# Access Compliance Report

## Public Rights-of-Way

### (Curb Ramps)

Intersection ID: 31750	Main Street: BRISBANE_CT	Cross Street: WASHOE_PINE_LN	Location: SE
ADA ID: 431E378C480C	Ramp Type: PerpDiag	Initial Pass/Fail: Fail	Overall Compliance: No
			Severity Score: 21.25

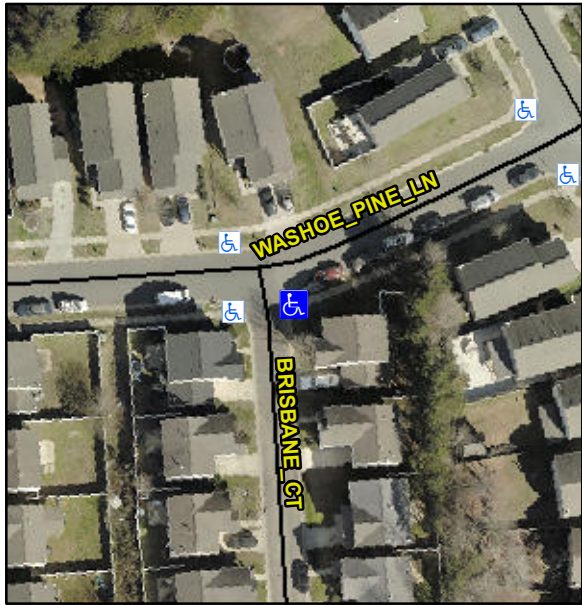
Codes/Mitigation Info/Possible Solution		Field Measurements/Component Compliance					
	Possible Solutions:						
	<b>Remove &amp; Replace Curb Ramp With Two New Directional Ramps or Equivalent.</b>	N/A	Ramp Length (in)	46.0	Yes	Ramp Slope (%)	6.3
		No	Ramp Width (in)	47.5	No	Ramp XSlope (%)	6.0
		N/A	Flare Type LT	N/A	N/A	Flare Type RT	N/A
		N/A	Flare Slope LT (%)	N/A	N/A	Flare Slope RT (%)	N/A
		N/A	Flare Traversable LT?	N/A	N/A	Flare Traversable RT?	N/A
		N/A	Landing Length (in)	N/A	N/A	DWS Provided?	N/A
		N/A	Landing Width (in)	N/A	N/A	DWS Contrast?	N/A
		N/A	Landing Slope (%)	N/A	N/A	DWS Length (in)	N/A
		N/A	Landing X Slope (%)	N/A	N/A	DWS Full Width?	N/A
Surveyor Notes:	<b>N/A</b>	N/A	Landing Curb? (Y/N)	N/A	N/A	DWS Offset (in)	N/A
		N/A	Shared Landing?	N/A			
		N/A	Gutter Ponding?	N/A	N/A	Gutter Slope (%)	N/A
		N/A	Gutter Lip Ht (in)	N/A	N/A	Gutter X Slope (%)	N/A
		N/A	Painted X Walk1?	No	N/A	Painted X Walk2?	No

X Walk 1 Direction	To N		X Walk 2 Direction	To W
		N/A	X Walk 1 Width (in)	N/A	N/A	X Walk 2 Width (in)	N/A
			X Walk 1 Slope (%)	1.7		X Walk 2 Slope (%)	4.0
			X Walk 1 X Slope (%)	6.4		X Walk 2 X Slope (%)	4.9
		N/A	Ramp inside XWalk1?	N/A	N/A	Ramp inside XWalk2?	N/A
PROW/ADA:	<b>Not Found, R304.5.1, R304.5.3</b>		Road Slope (%)	6.0	N/A	Clear Space?	N/A
			Road X Slope (%)	2.2	N/A	Clear Space to XWalk (in)	N/A
		N/A	Any Obstructions?	N/A	N/A	Storm Grate/Utility Hazard?	N/A
			Obstruction Type			Storm Grate/Utility Type	
				N/A			N/A
					Yes	Surface Condition? (G/P)	Good
Total Cost:		\$	3200.00
